# SITE PLAN

**Reviewed for Code Compliance**  
 Approved by: Brandon Zipser  
 Permit #: **541-21-000119-STR**  
 Date: **04/15/2021**  
 Reviewed for Lincoln City

SITE PLAN  
6600 LOGAN RD.  
LINCOLN CITY, OREGON  
SCALE: 1" = 20.00'

2400 PLAN  
 6600 LOGAN RD.  
 LINCOLN CITY, OREGON

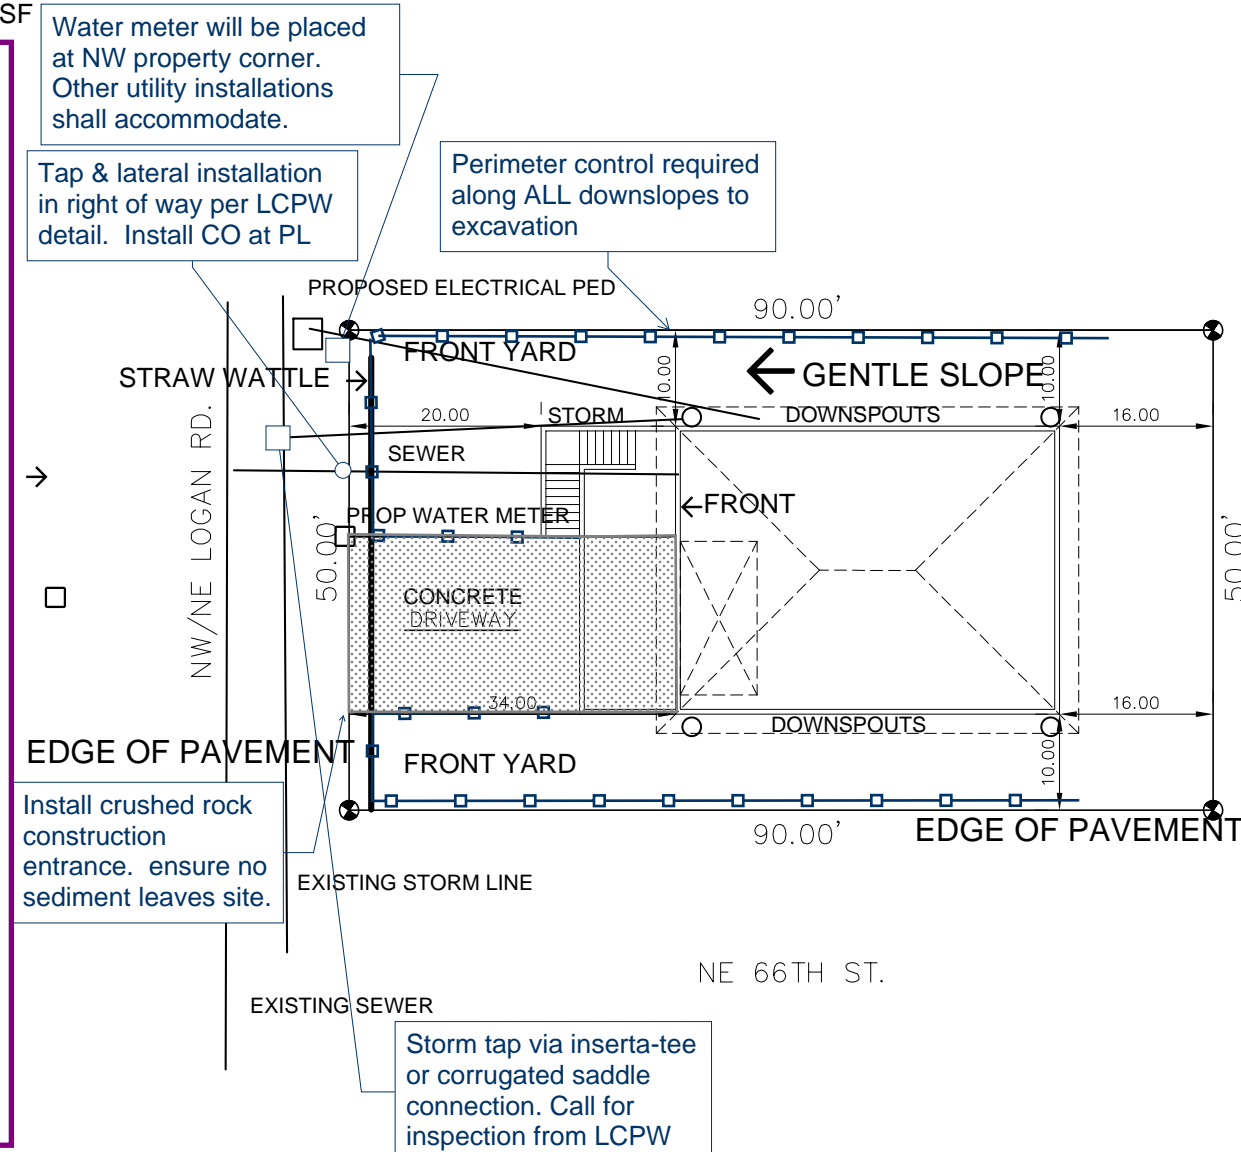
- Residential Landscape Plan Required
- Driveway must be asphalt/concrete/pavers
- ALL utilities must underground (Includes cable, phone, & electric)

Water meter will be placed at NW property corner. Other utility installations shall accommodate.

Tap & lateral installation in right of way per LCPW detail. Install CO at PL

Perimeter control required along ALL downslopes to excavation

Install crushed rock construction entrance. ensure no sediment leaves site.

Storm tap via inserta-tee or corrugated saddle connection. Call for inspection from LCPW

**ROW IMPROVEMENTS: FULL ENGINEER PLANS SHALL BE SUBMITTED FOR APPROVAL IN ACCORDANCE WITH THE REQUIREMENTS OF 17.52.230. IMPROVEMENTS SHALL BE COMPLETED, INSPECTED, AND APPROVED BY LCPW PRIOR TO FINAL APPROVAL AND ISSUANCE OF BUILDING COA. DEFERRED SUBMITTAL AT OWNER'S REQUEST AND FULL LIABILITY**

**GRADING - NO GRADING PLAN SHOWN FOR APPROVAL. ALL GRADING TO BE COMPLETED ACCORDING TO LCPW STANDARDS AND LCMC. INQUIRE FOR QUESTIONS REGARDING GRADING APPROVAL PRIOR TO COMPLETION OF WORK.**

RIGHT ELEVATION SCALE: 1/4" = 1'-0"

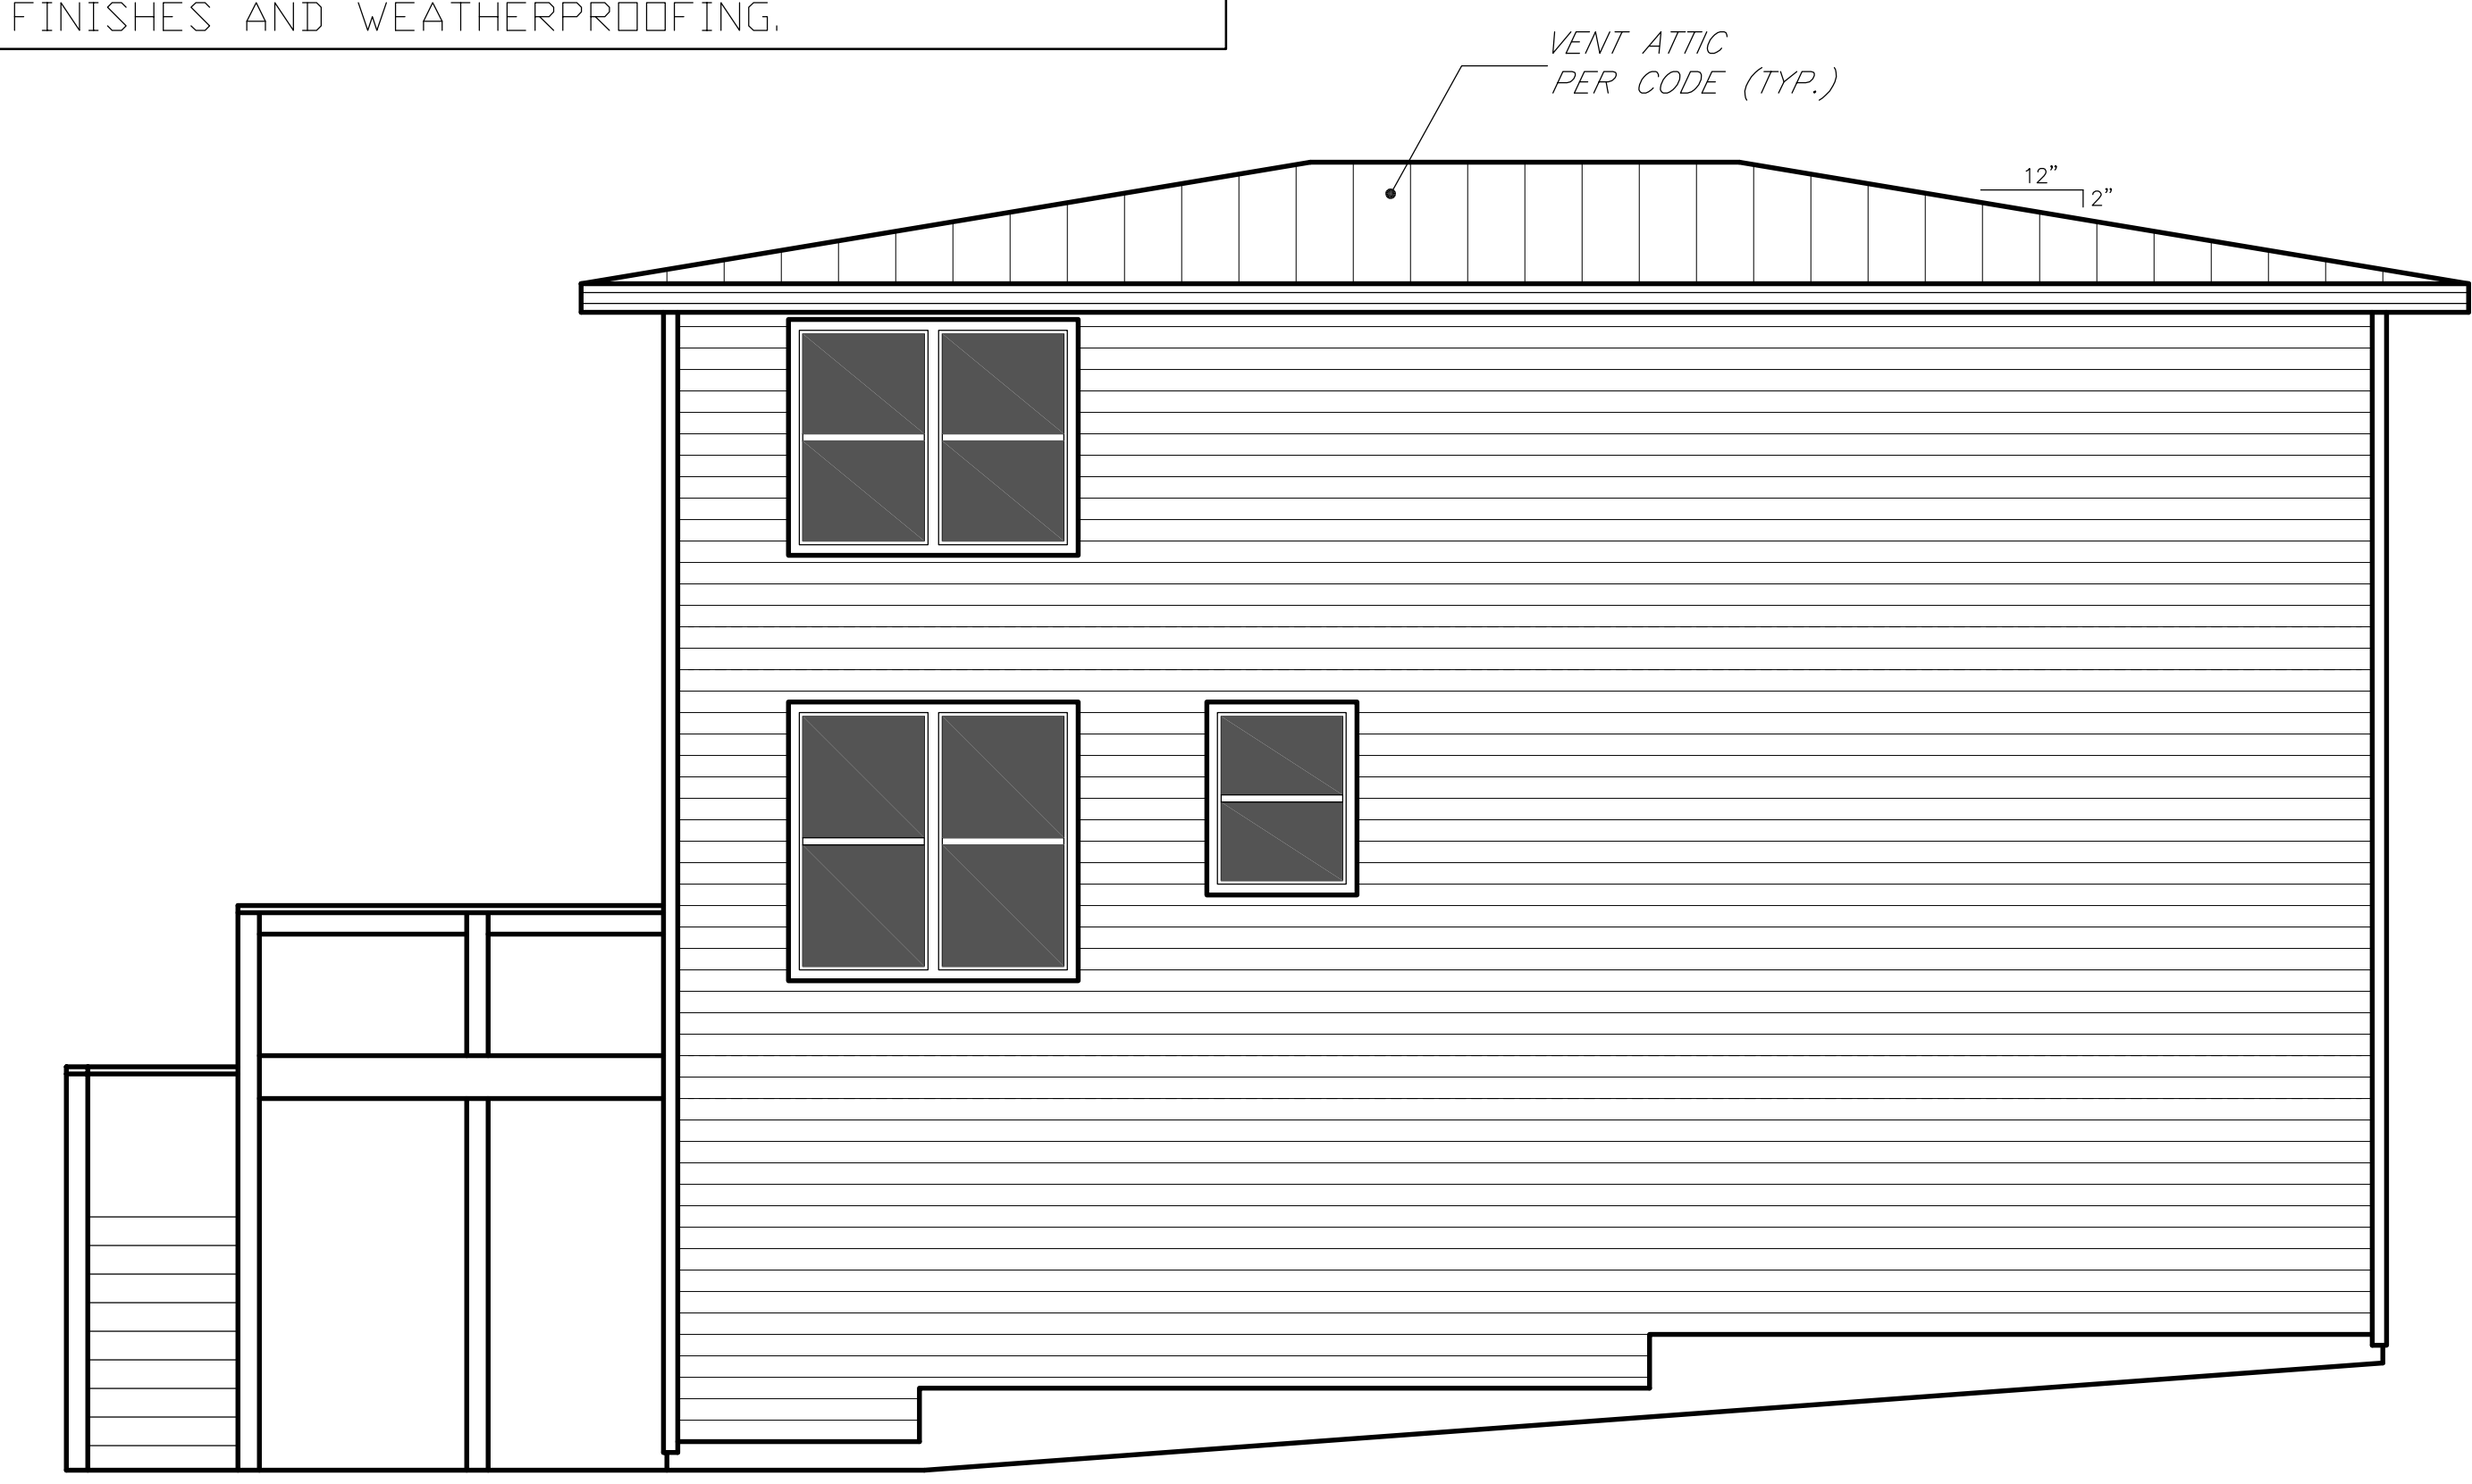
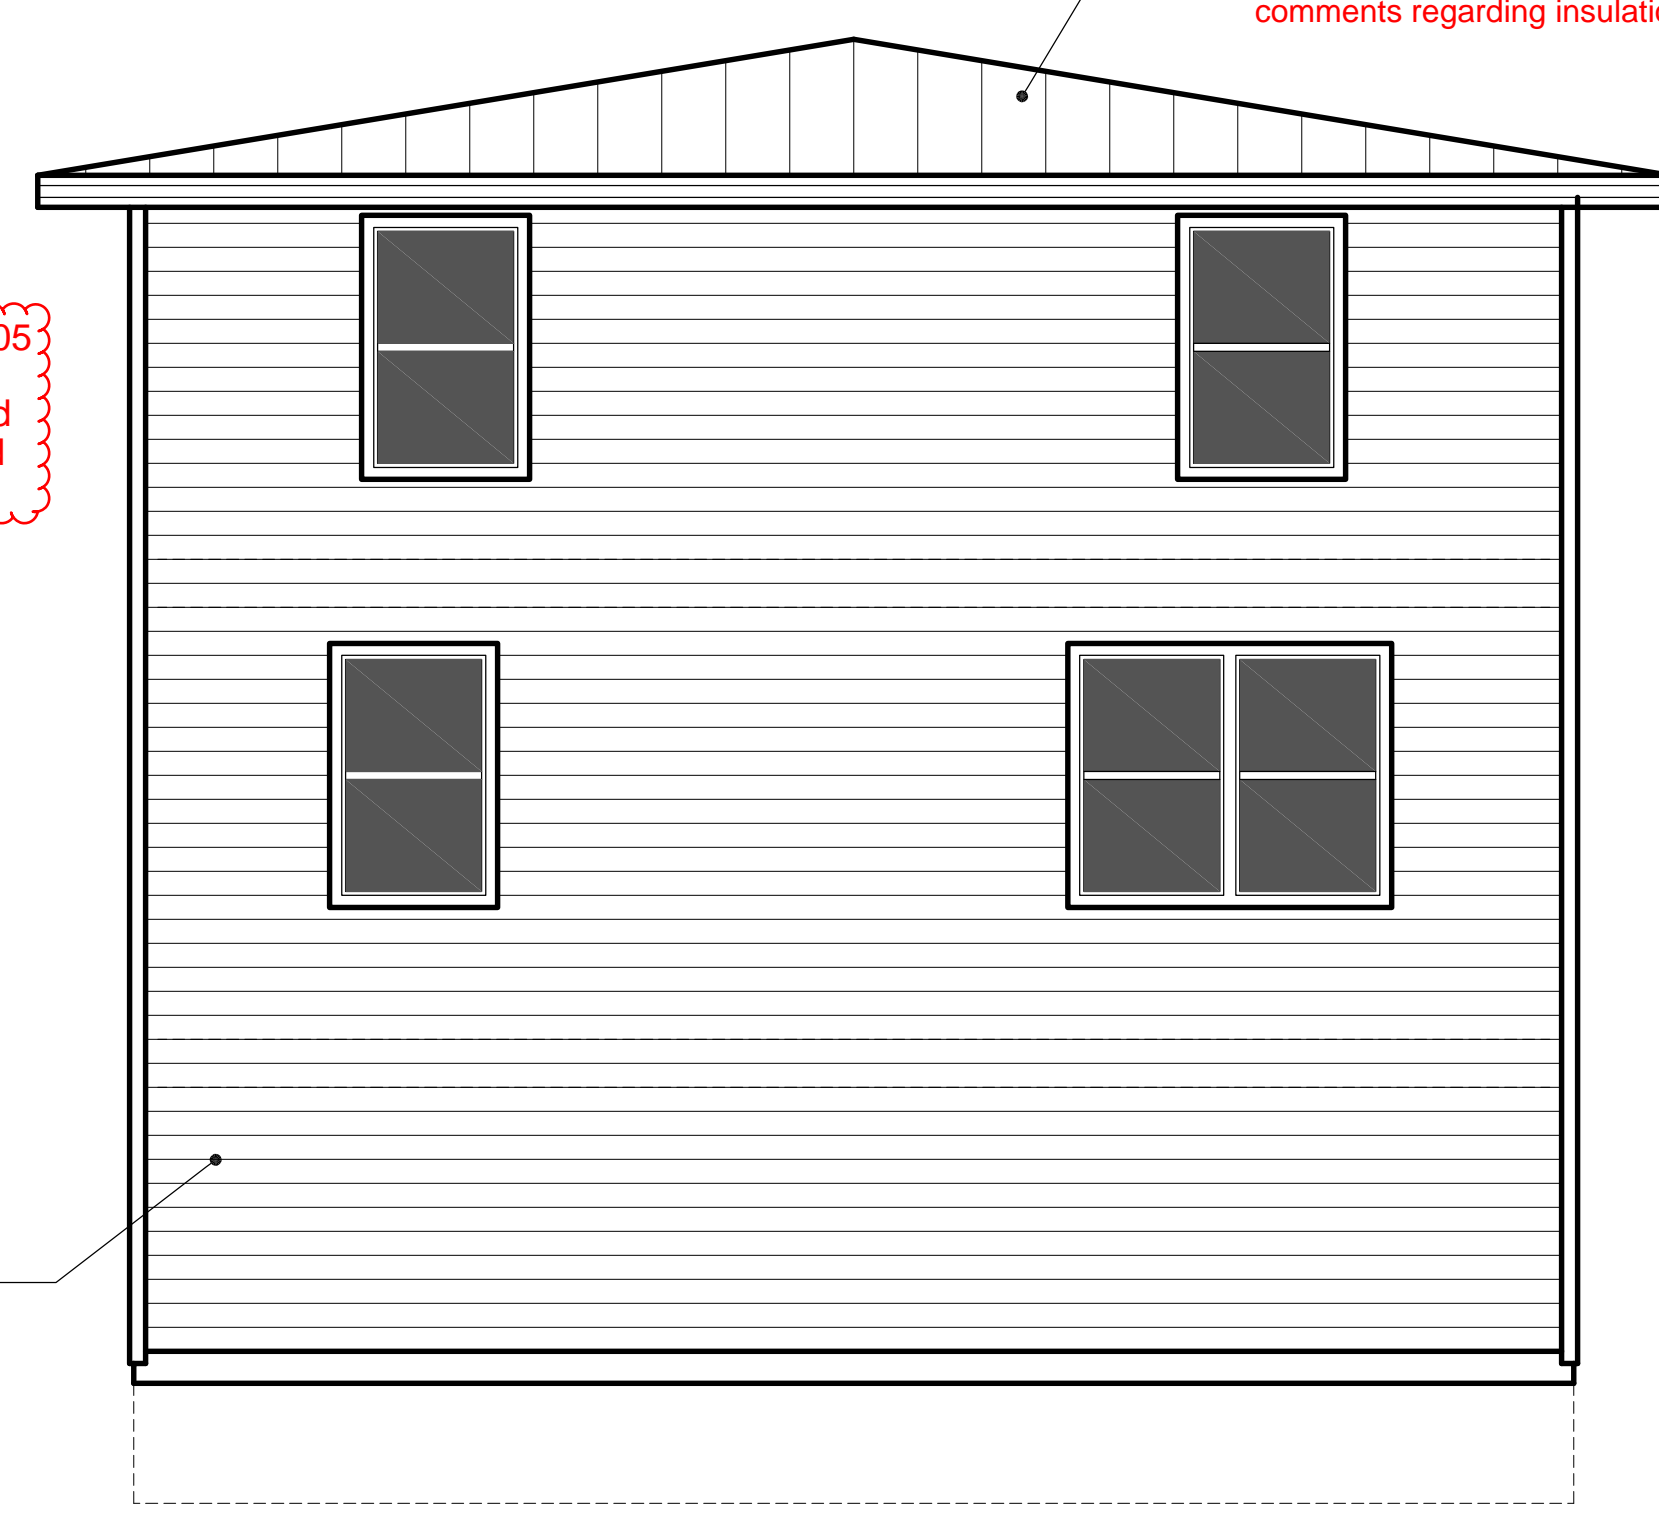
METAL ROOFING PER CONTRACTOR. INSTALL PER CODE AND OR MANUFACTURER'S INSTALLATION INSTRUCTIONS  
 Or approved low slope roofing product per MII's. See comments regarding insulation/ventilation materials.

All roofing and siding materials must be rated for 105 MPH wind. Corrosion resistant fasteners required (Highly recommend stainless steel). Eave, rake and kick out flashings required. Head flashings required above all projecting horizontal trim.
